PCN No.	2022011
Contact:	MPS-PCN@monolithicpower.com
Issue Date:	1/21/2022

PCN Basic Data			
Title of the Change:		MPL-SE2512 Series Shape of Core Material Change	
Change Category:	<input checked="" type="checkbox"/> Datasheet	<input checked="" type="checkbox"/> Design	<input type="checkbox"/> Process - Wafer
	<input type="checkbox"/> Process - Bumping	<input type="checkbox"/> Process - Assembly	<input type="checkbox"/> Process - Testing
	<input type="checkbox"/> Packing/Shipping	<input type="checkbox"/> Others:	
Change Level:	<input type="checkbox"/> Level 1	<input type="checkbox"/> Level 2	<input checked="" type="checkbox"/> Level 3
Origin of Change:	<input checked="" type="checkbox"/> MPS	<input type="checkbox"/> Customer:	
Product/Package Affected:	MPL-SE2512-R47, MPL-SE2512-R68, MPL-SE2512-1R0, MPL-SE2512-1R5, MPL-SE2512-2R2, MPL-SE2512-3R3, MPL-SE2512-4R7, MPL-SE2512-100, MPL-SE2512-150, MPL-SE2512-220		
Description of Change			
No.	Category	Old	New
1	Design Shape of core material

Recommended Land Pattern

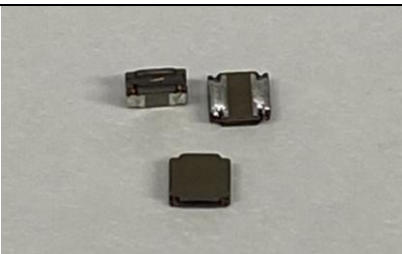
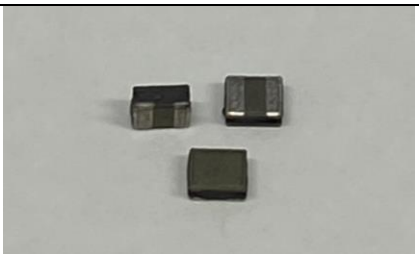
Land Pattern	Part Number	Current			New		
		A (mm)	B (mm)	C (mm)	A (mm)	B (mm)	C (mm)
	MPL-SE2512-R47	2.10 ref.	0.80 ref.	2.60 ref.	2.40 ref.	1.00 ref.	2.90 ref.
	MPL-SE2512-R68	2.10 ref.	0.80 ref.	2.60 ref.	2.40 ref.	1.00 ref.	2.90 ref.
	MPL-SE2512-1R0	2.10 ref.	0.80 ref.	2.60 ref.	2.40 ref.	1.00 ref.	2.90 ref.
	MPL-SE2512-1R5	2.10 ref.	0.80 ref.	2.60 ref.	2.40 ref.	1.00 ref.	2.90 ref.
	MPL-SE2512-2R2	2.10 ref.	0.80 ref.	2.60 ref.	2.40 ref.	1.00 ref.	2.90 ref.
	MPL-SE2512-3R3	2.10 ref.	0.80 ref.	2.60 ref.	2.40 ref.	1.00 ref.	2.90 ref.
	MPL-SE2512-4R7	2.10 ref.	0.80 ref.	2.60 ref.	2.40 ref.	1.00 ref.	2.90 ref.
	MPL-SE2512-100	2.10 ref.	0.80 ref.	2.60 ref.	2.40 ref.	0.80 ref.	2.90 ref.
	MPL-SE2512-150	2.10 ref.	0.80 ref.	2.60 ref.	2.40 ref.	0.80 ref.	2.90 ref.
	MPL-SE2512-220	2.10 ref.	0.80 ref.	2.60 ref.	2.40 ref.	0.80 ref.	2.90 ref.
